**Subject: UR Brite Cleaners
Response to Agency Comments
Remedial Action Plan Submittal – Final – Revision 1
Facility ID #069600002
Task Assignment #HW510-D12F**

REMEDIAL ACTION PLAN

**REMEDIAL ACTION PLAN – Final
Soil Vapor Extraction System**

Appendix C
Johnsons Equations Calculations (Median)
Three Vapor Extraction Wells

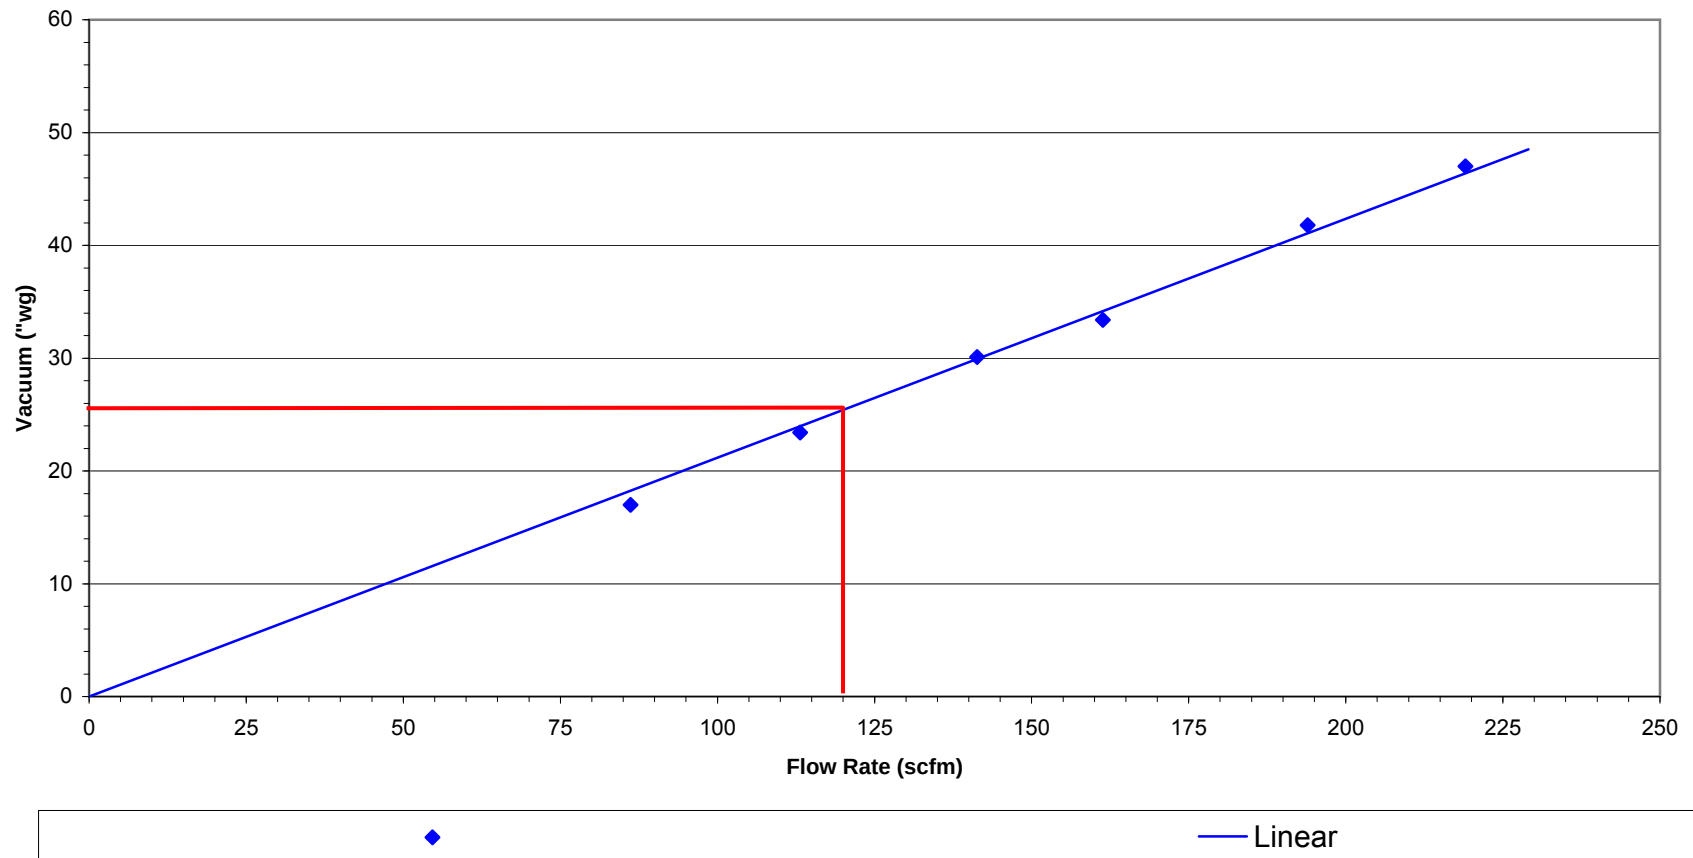
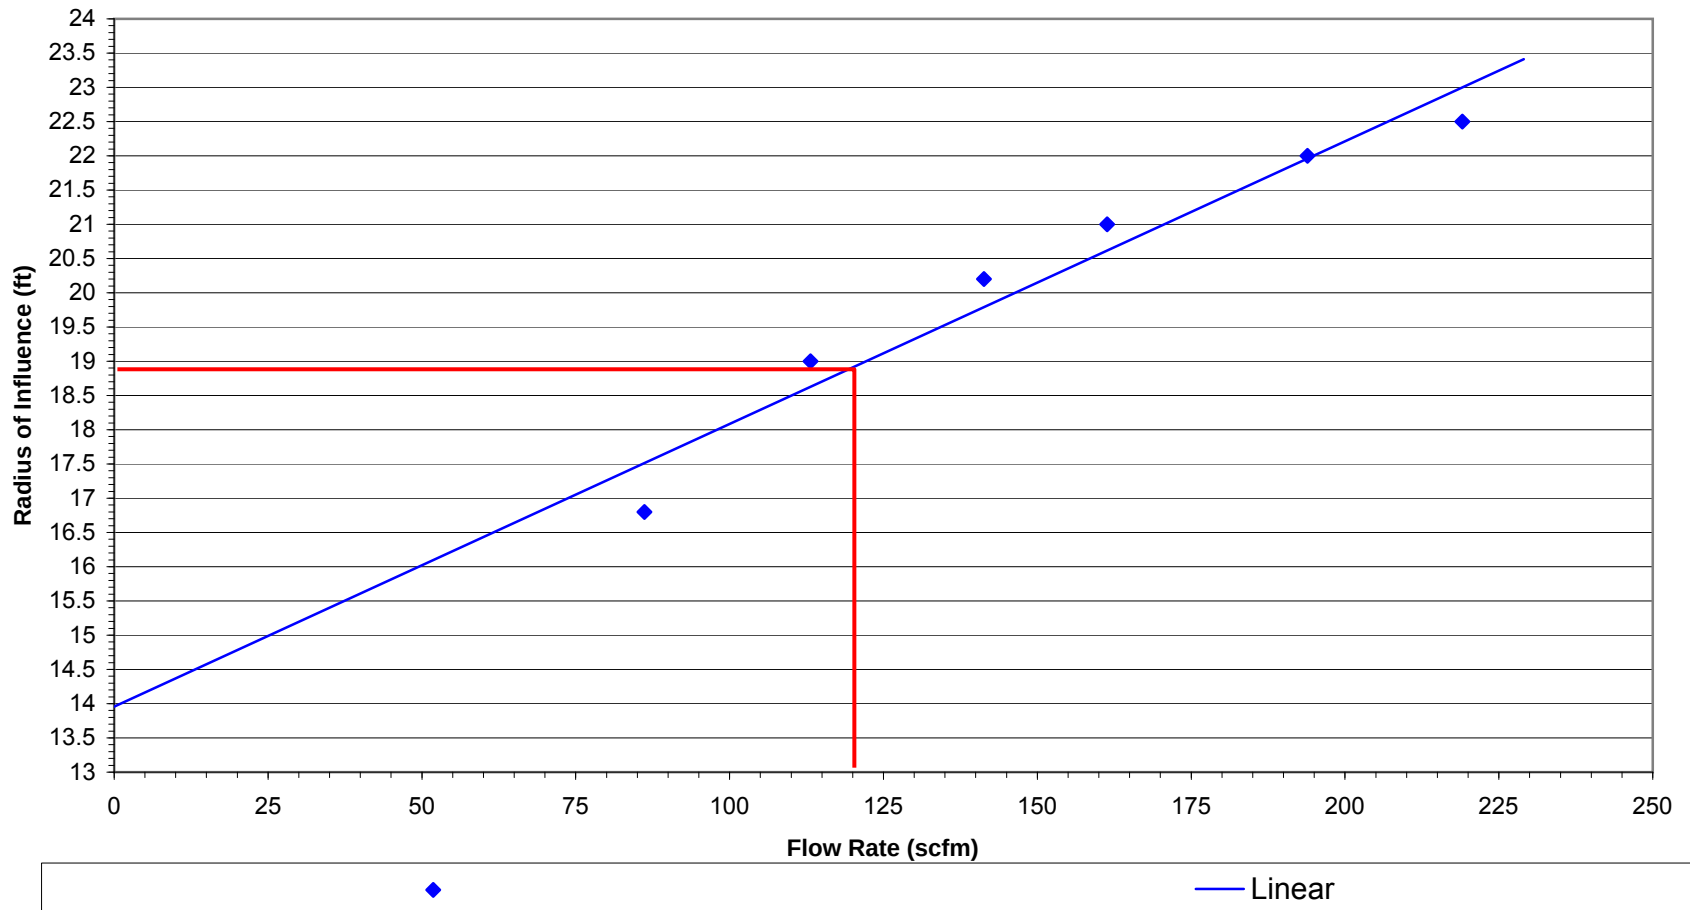
Item 2 Section 5.1.2: is a design flow rate of 120 scfm per VEW well achievable? Please, have M&E verify the SVE design calculations using Johnson's equation for this site.

Step test data show that the blower can operate @ 120 CFM when using the 15-hp blower. This will still give us the required ROI. The Johnson's equations calculations using the design vacuum of 25" in wg at each well, the total flow rate of 360 scfm, and the data available from Elite cleaners is included in Appendix C, SVE Design Calculations.
